## COLLINS RADIO COMPANY

EQUIPMENT SERIES: 32S

BULLETIN NO. 3

SUBJECT: ADD VOX RELAY TIME CONSTANT CONTROL.

Figure 1. 32S-1/2 VOX Time Control Circuit Changes

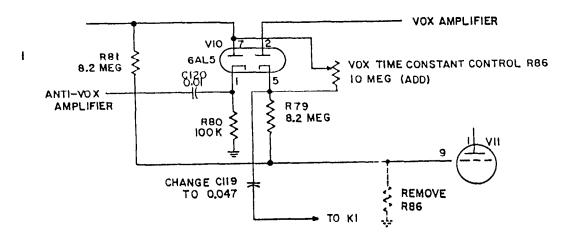
Modifying Transmitters 32S-1/2 according to this bulletin will allow the time constant of the vox control relay to be adjusted. Adjusting the time constant will enable the operator to obtain a more uniform operation of the relay by compensating for variations in microphone and voice characteristics. Increasing the time constant will increase the time between the last spoken word or keyed character and the release of the relay; decreasing it will have converse effects.

Refer to figure 1 for circuit changes.

Figure 2. Parts Location - After Modification

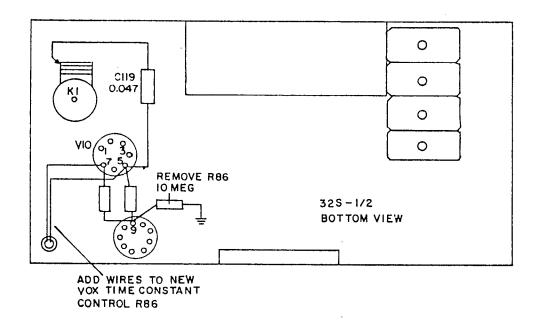
- 1. Remove feet from cabinet.
- 2. Lift lid and remove the two unpainted screws from top rim of front panel.
- 3. Slide unit out of cabinet.
- 4. Remove and discard 10-megohm resistor R86 connected between V11, pin 9 and ground. Refer to figure 2.
- 5. Remove and discard 0.022-uf capacitor Cl19 connected between V10, pin 5 and vox relay K1. Replace with 0.047-uf capacitor (931-0295-00). Use sleeving (152-1613-00) on leads. Refer to figure 2.
- 6. Solder an 18-inch length of wire (439-7036-00) to V10, pin 7 and another 18-inch length to V10, pin 5. Lay wires along chassis and through cable grommet hole (in corner near front panel) to the top of the chassis.
- 7. With unit in upright position, remove VOX GAIN control knob and mounting hardware. Do not unsolder.
- 8. Mount new VOX TIME CONSTANT control (376-7206-00) in bracket (546-7972-002) using the knob and hardware included in kit.

Figure 3. Mounting VOX Time Constant Control

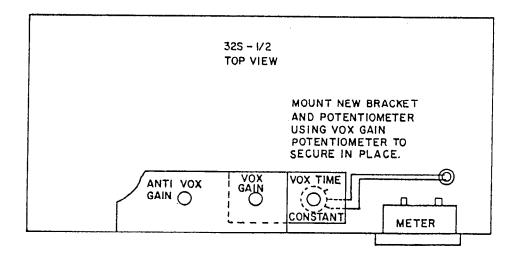
- 9. Place VOX TIME CONSTANT control bracket over the shaft of the VOX GAIN control and insert VOX GAIN control in its original position. Tighten mounting hardware. Refer to figure 3.
- Solder one of the 18-inch wires to center terminal of VOX TIME CON-STANT control.
- 11. Solder remaining 18-inch wire to the counterclockwise (viewed from shaft end) terminal of VOX TIME CONSTANT control as shown in figure 3.
- 12. Reassemble unit.
